**Building Code of Australia Assessment
Report (Sections C, D & E)**

53A Ross Street, Glebe

Jake Dowse Architects

Report No: 2023
Dated: 29th April 2020

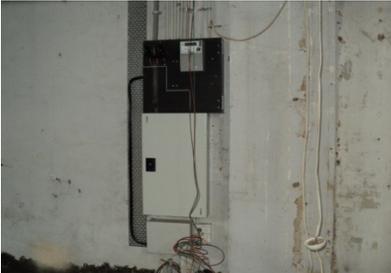
Clause	Description	Assessment
C3.0	Deemed-to-Satisfy Provisions	Noted.
C3.1	Application of part	Noted.
C3.2	Protection of openings in external walls	<p>Non-compliance noted.</p> <p>There are openings located less than the required 3m from the boundaries.</p> <p>A Performance based assessment (Fire Engineered Solution) has been carried out / developed by Design Confidence (Report Reference P220_152-2 (FER) CL dated 29th April 2020).</p> <p>Requirements of Fire Engineered Solution must be included in the Fire Safety Schedule for the building.</p> <p>Refer to Recommendation 3.2</p>
C3.3	Separation of external walls and associated openings in different fire compartments	Not applicable.
C3.4	Acceptable method of protection	Noted. Refer to Clause 3.2 above and Recommendation 3.2 of this report.
C3.5	Doorways in fire walls	Not applicable.
C3.6	Sliding fire doors	Not applicable.
C3.7	Protection of doorways in horizontal exits	Not applicable.

There are openings located less than the required 3m from the boundaries.

A Performance based assessment (Fire Engineered Solution) has been carried out / developed by Design Confidence (Report Reference P220_152-2 (FER) CL dated 29th April 2020).

Requirements of Fire Engineered Solution must be included in the Fire Safety Schedule for the building.

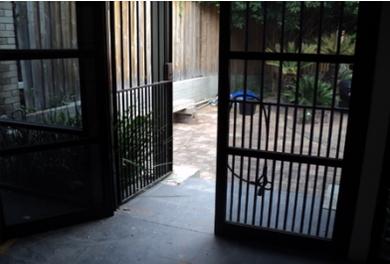
Clause	Description	Assessment
D1.0	Deemed-to-Satisfy Provisions	Noted.
D1.1	Application of part	Noted.
D1.2	Number of exits required	Complies. One [1] <i>exit required</i> (building less than 25m effective height).
D1.3	When fire isolated exits are required	Not applicable. A fire isolated stair is not required in this building.
D1.4	Exit travel distances	Complies. Single storey Class 5 & 6 buildings that exit to road or open space are permitted to have an exit travel distance of not more than 30m. Measurements taken on site confirm a maximum exit travel distance of only 23m (currently open plan). Final fit out to ensure exit travel distance of less than 30m is maintained.
D1.5	Distance between alternative exits	Not applicable.
D1.6	Dimensions of exits and path of travel to exits	Complies. Open plan building. If final exit door is to be altered in the future, a minimum
